Geotechnical Exploration, Inc.

Job No. 16-11251

Subject: **Response to City of San Diego Cycle Review Comments LDR-Geology: Project No. 508125, Cycle Issue 11**
Proposed Foxhill Residence
7007 Country Club Drive
La Jolla, California

Foxhill Residence
 7007 Country Club Drive
 La Jolla, CA.
 Figure No. 1a
 Job Number 16-11256

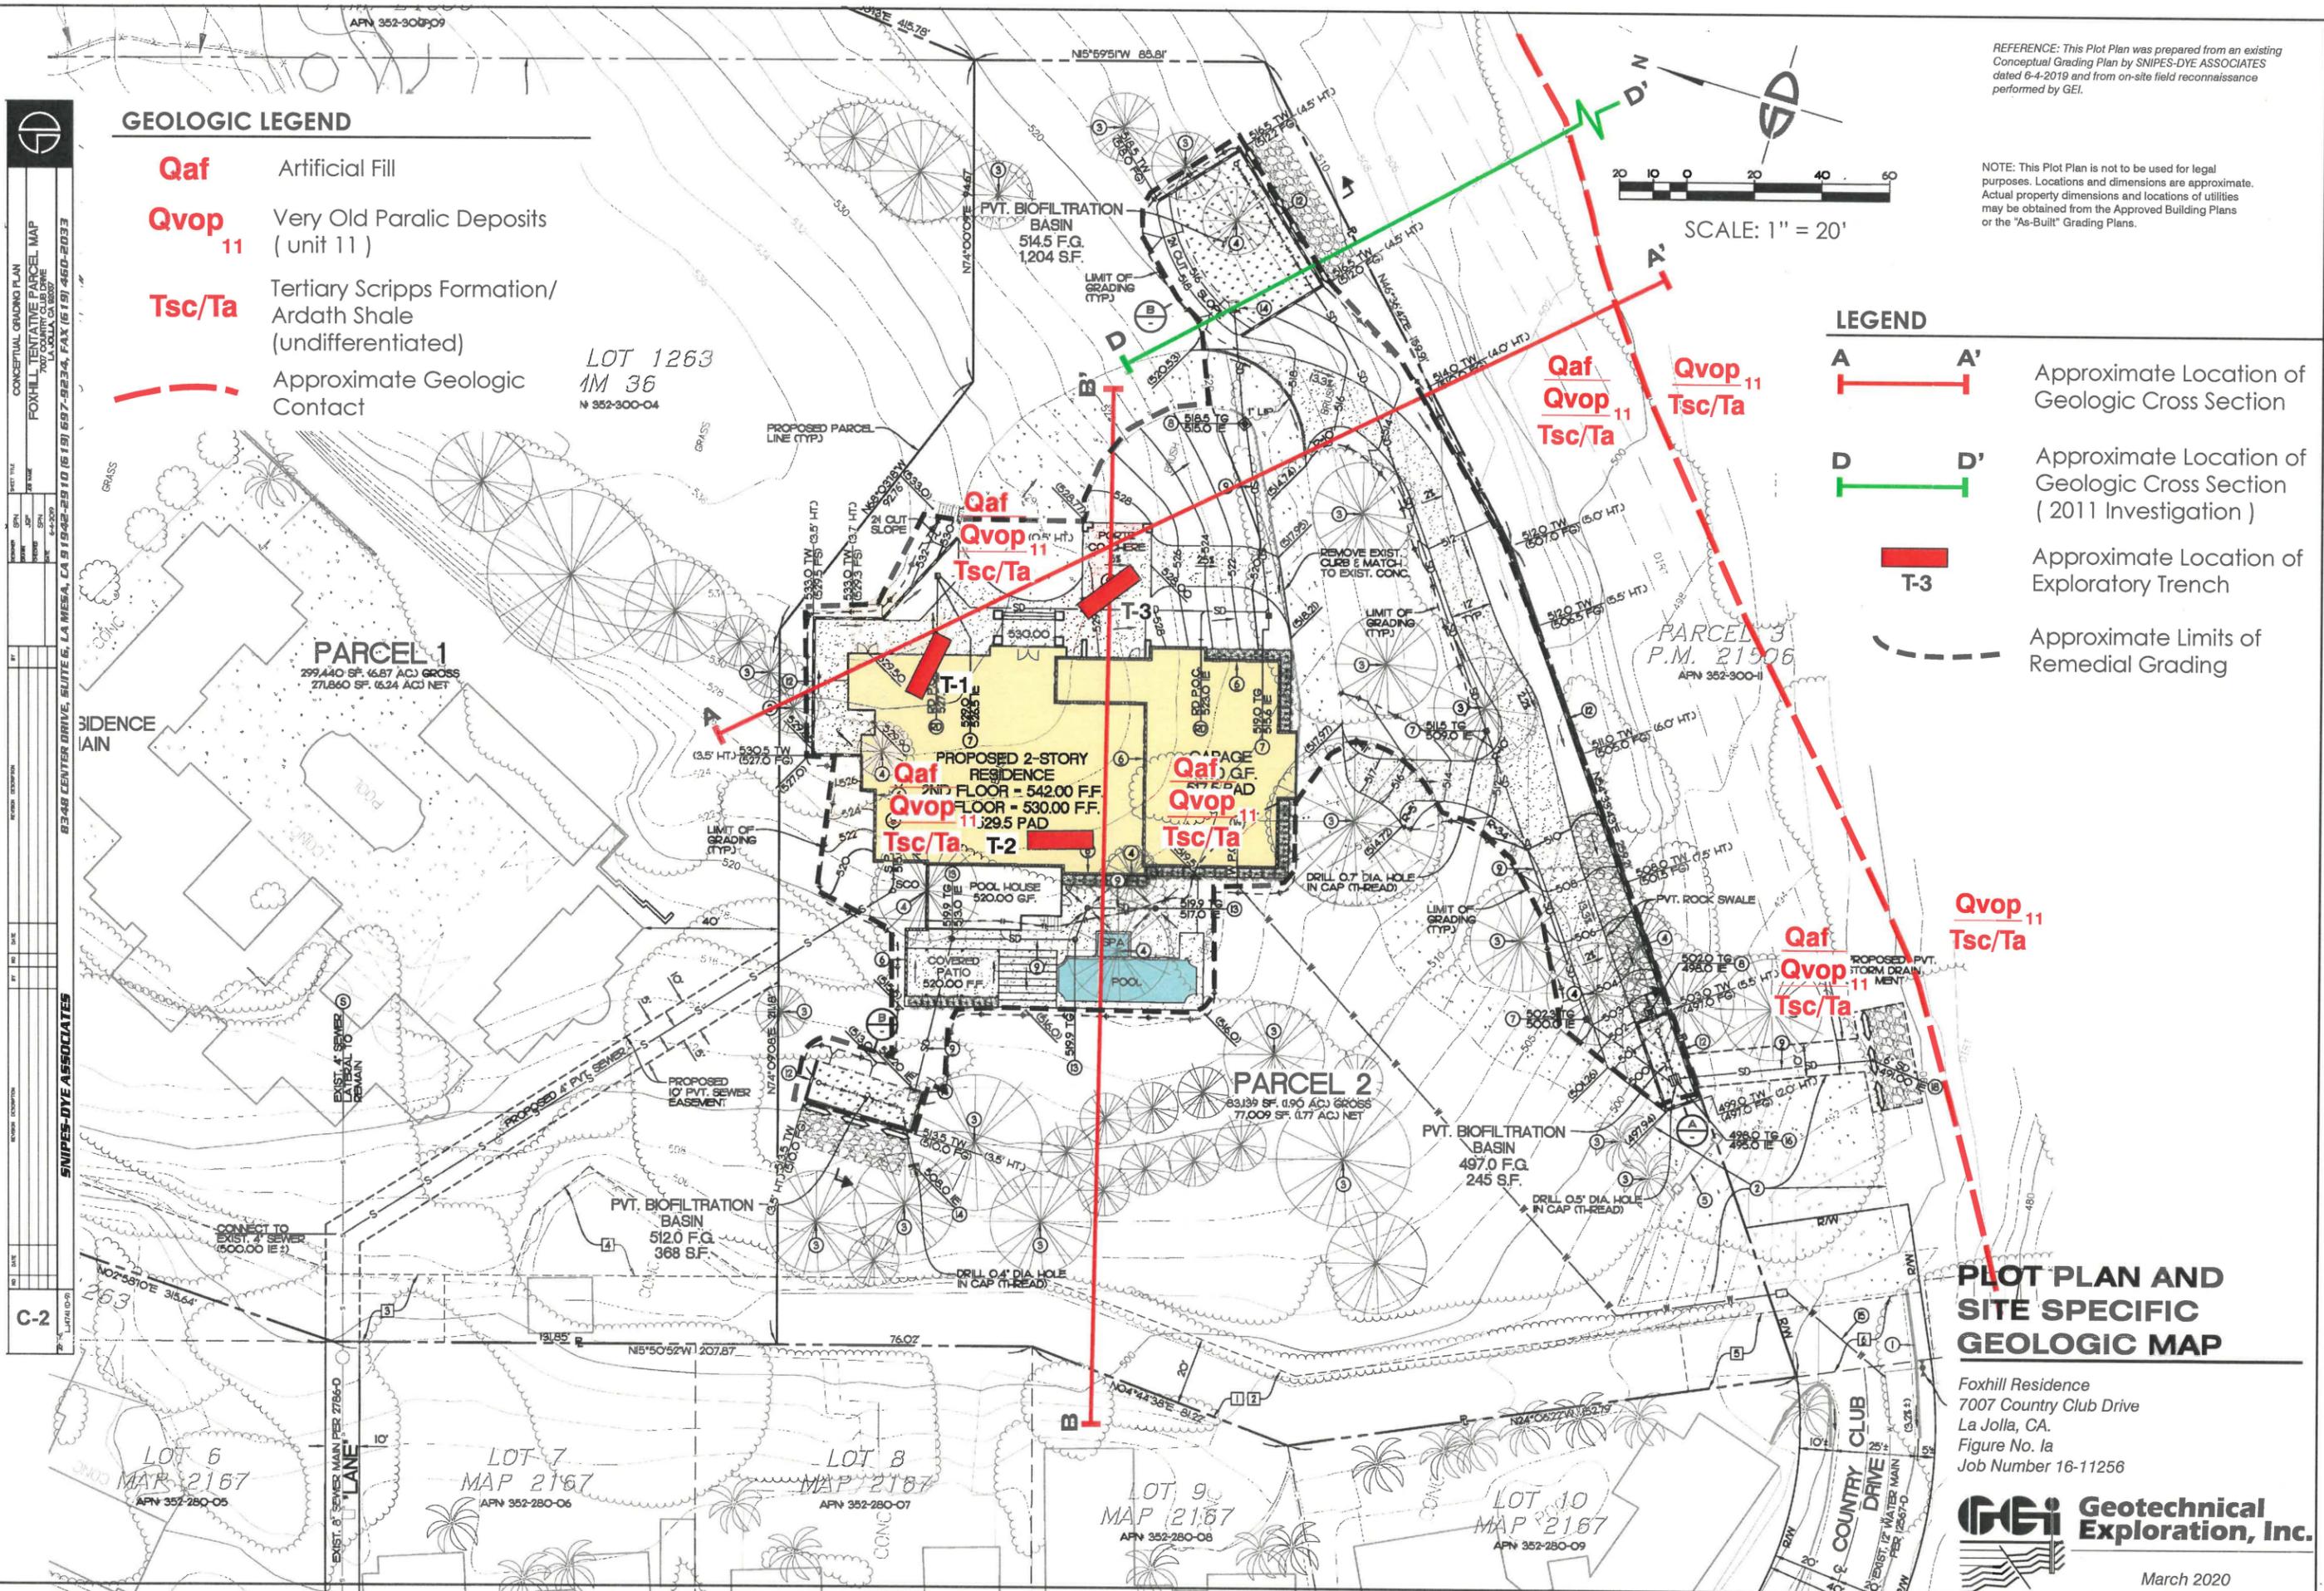
Issue No. 4: The project's geotechnical consultant must circumscribe the area of remedial grading recommended on the geologic/geotechnical map. (Outstanding Issue from Cycle 2)

GEI Response: We have included a site specific geologic/geotechnical map that circumscribes the area of recommended remedial grading on a topographic-based map with this update letter as Figure No. Ia.

Foxhill Residence
7007 Country Club Drive
La Jolla, CA.
Figure No. 1b
Job No. 16-11251

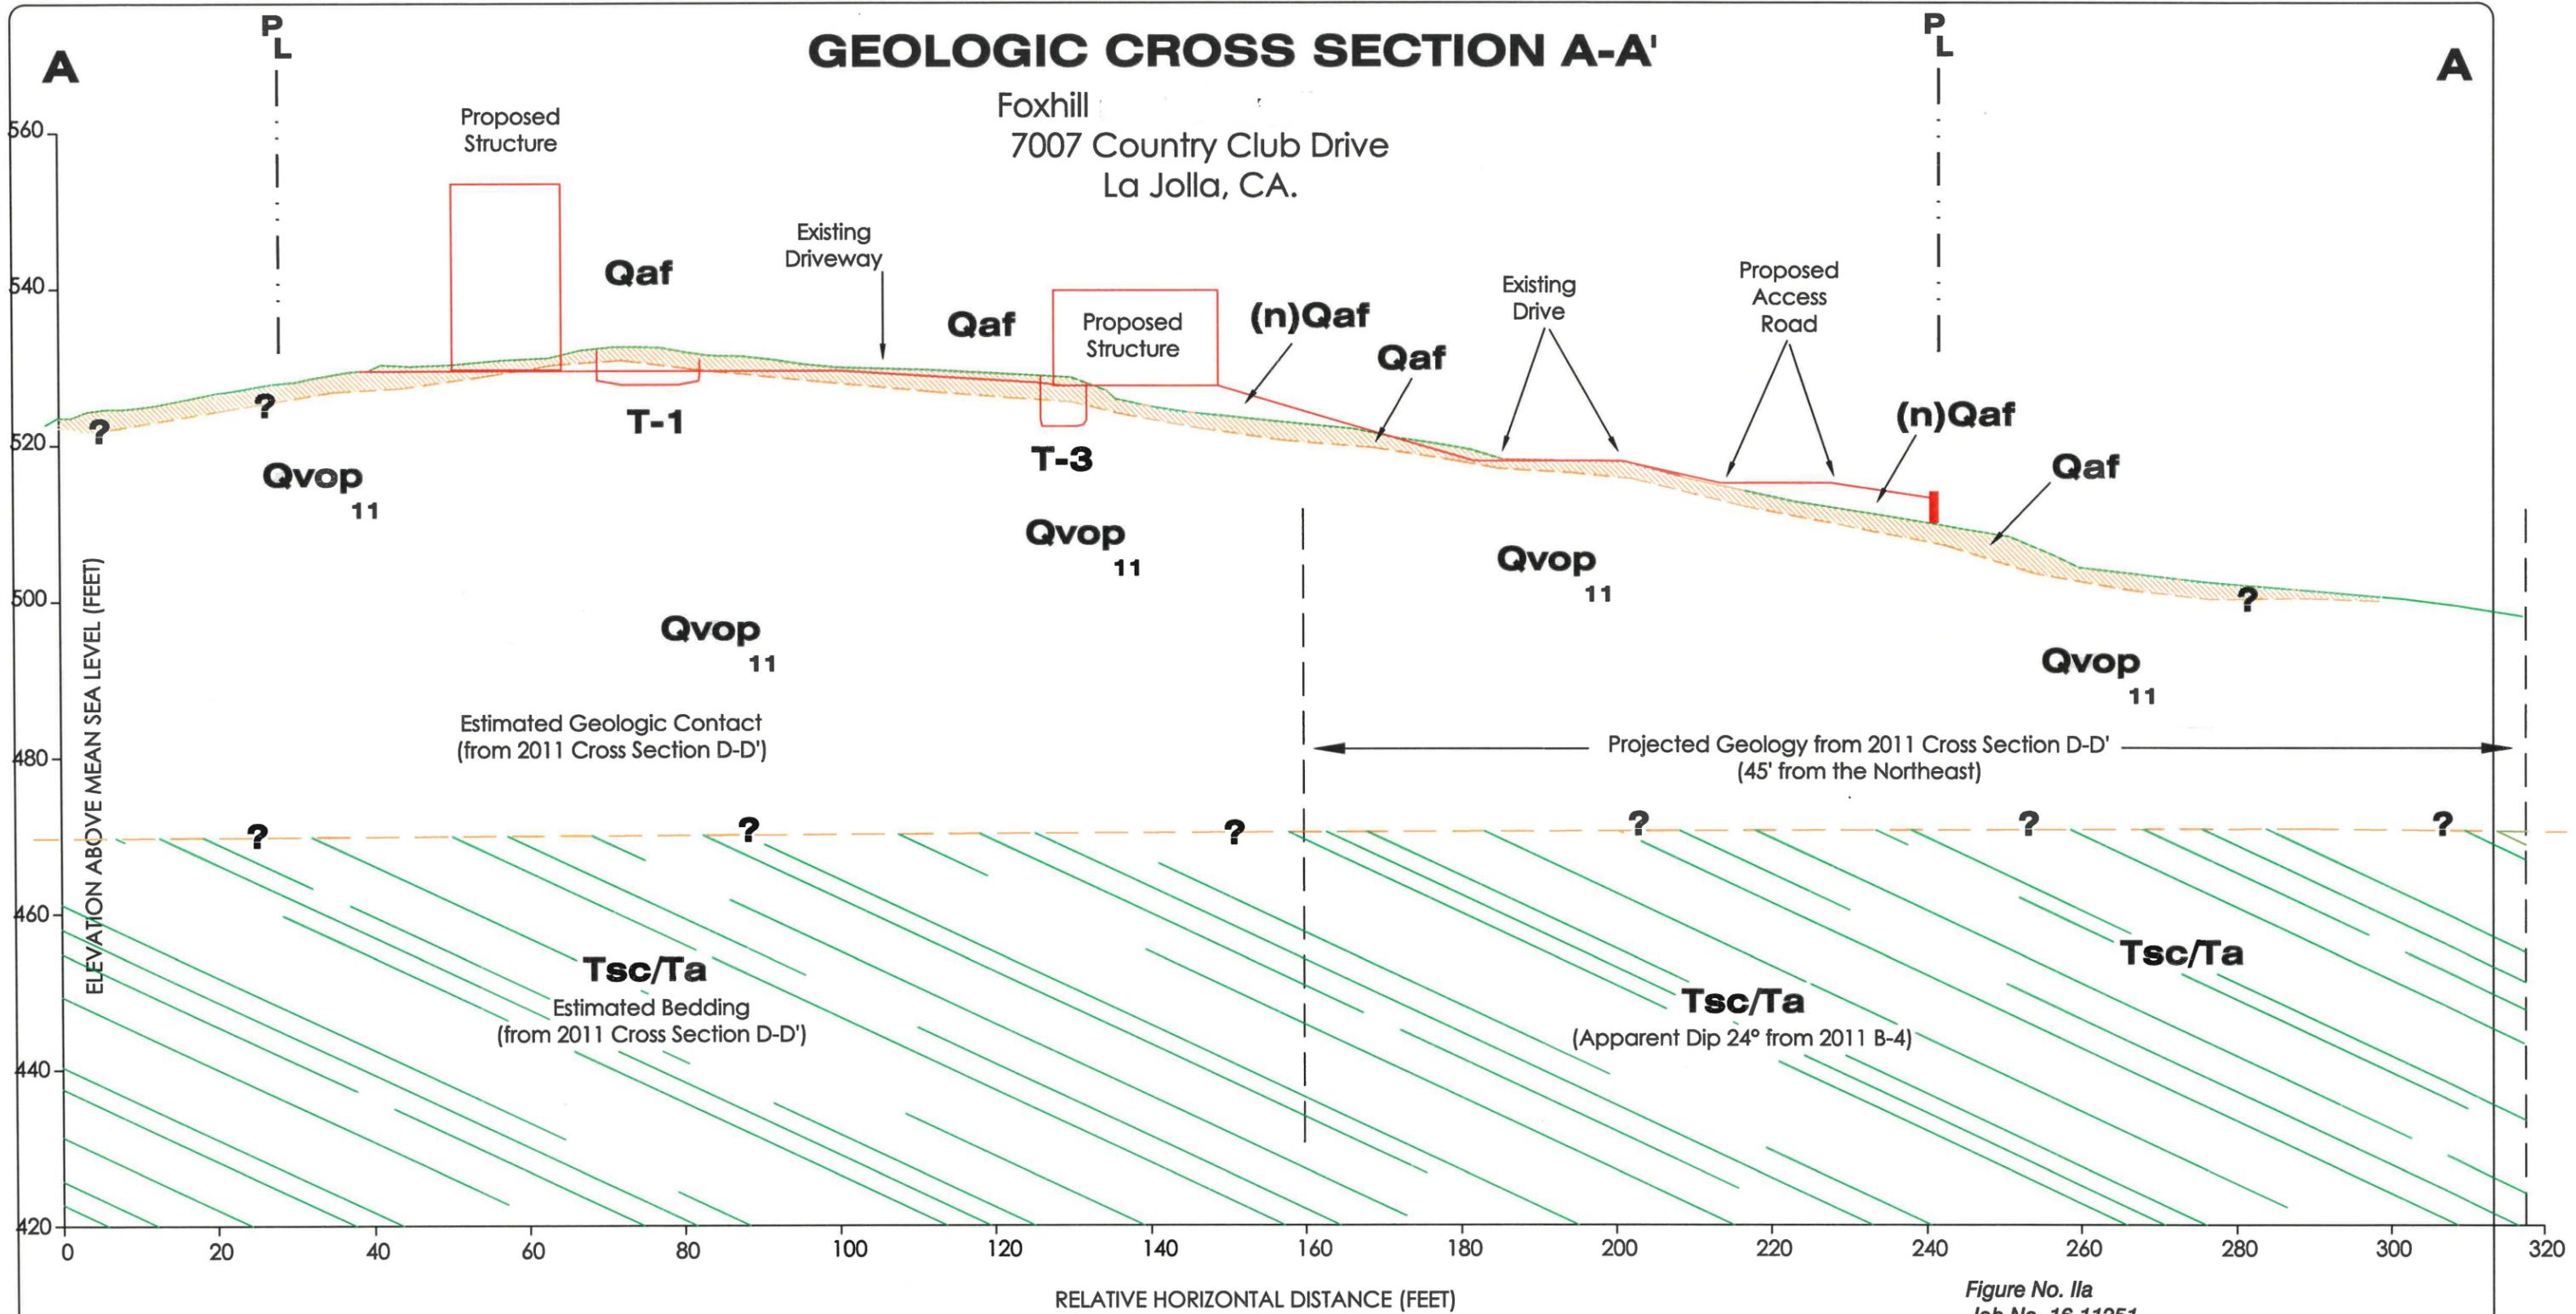
Issue No. 6: According to the San Diego Seismic Safety Study Geologic Hazard Maps, a portion of the access road for the guesthouse is located in geologic hazard category 22, indicating potential slope instability, possible or conjectured landslide. Clarify if the site or any portion of the site is located on or adjacent to a landslide. Provide the rationale and site-specific physical evidence used to support a determination regarding the presence or absence of landsliding at the site. (Outstanding Issue from Cycle 2)

Along with geologic cross-sections A-A' and B-B' provided for this update letter, we have included a revised geologic cross-section D-D' and exploratory boring (B-1) log for the adjacent parcel from our "Report of Preliminary Geotechnical and Geologic Investigation," dated November 16, 2011. Please, refer to Figure Nos. Ia-b for the geologic cross-section locations on the Plot Plans with Site-Specific Geology. Refer

Figure No. 11b
Job No. 16-11251

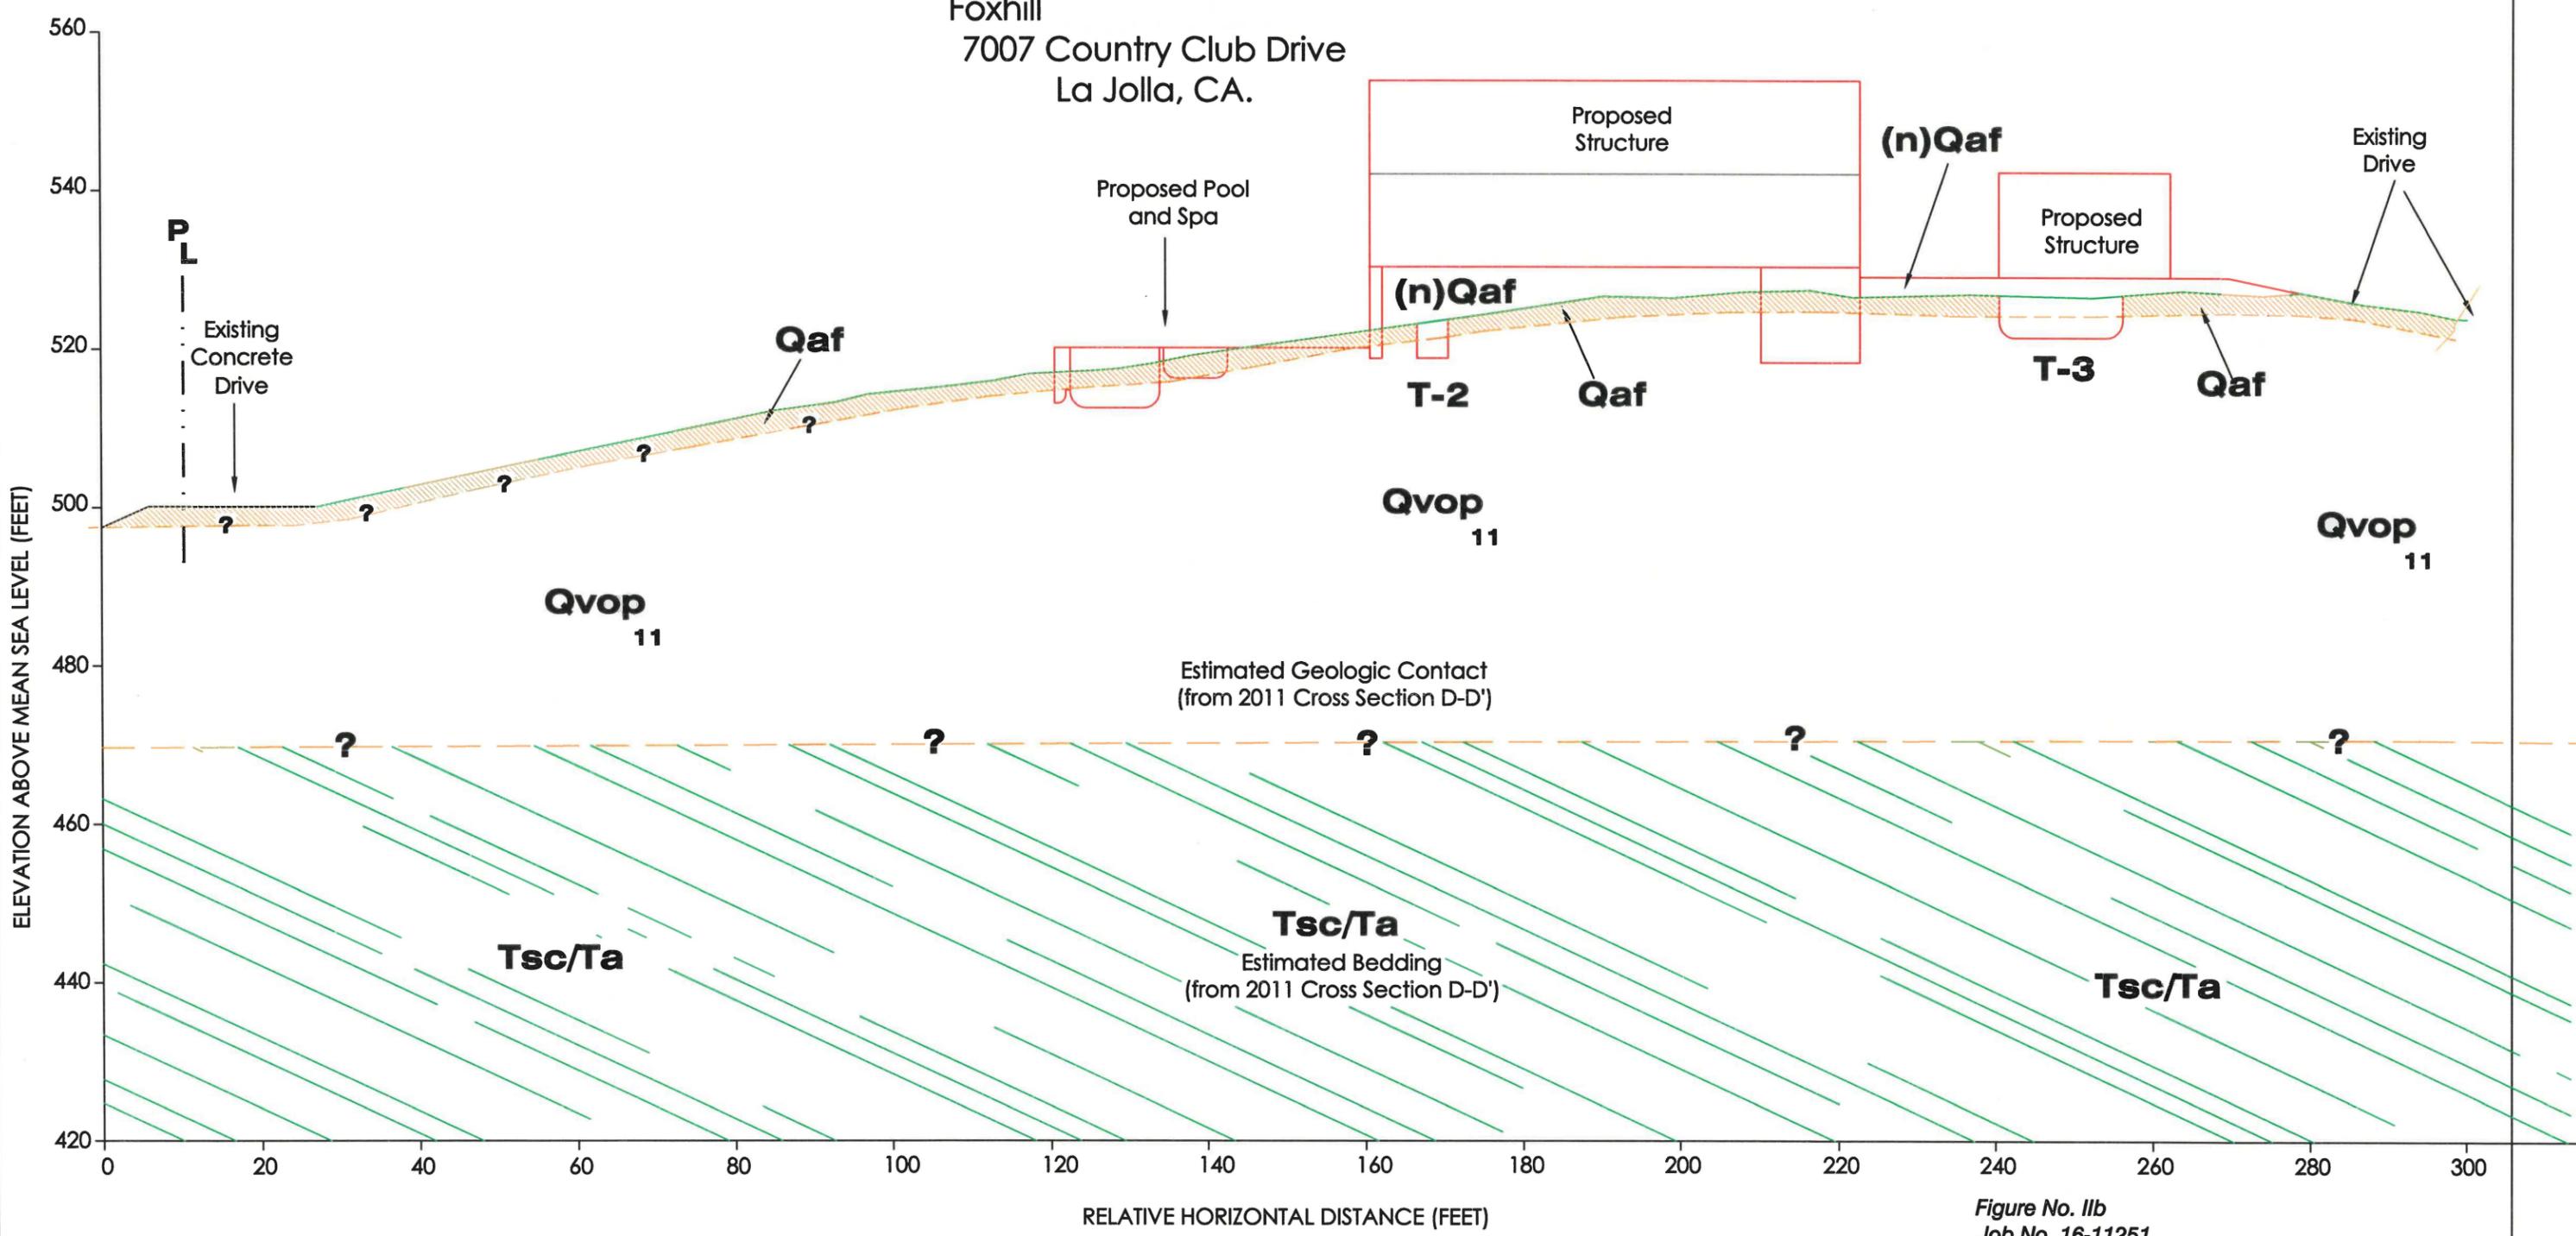
Issue No. 5: Provide geologic/geotechnical cross-sections representative of the site conditions and proposed grading. (Outstanding Issue from Cycle 2)

GEI Response: We have included geologic/geotechnical cross-sections representative of the site conditions and proposed grading from the referenced architectural and grading plans with this update letter as Figure Nos. IIa-b. In addition, we have included a revised geologic cross-section D-D' from our "Report of Preliminary Geotechnical and Geologic Investigation, Copley Press Residential Project," dated November 16, 2011, of the adjacent parcel (APN 352-300-04-00) and a portion of the subject site. Please, refer to Figure Nos. Ia-b for the geologic cross-section locations on the Plot Plans with Site-Specific Geology. Refer to Figure No. IIC for the revised Geologic Cross-Section D-D'.
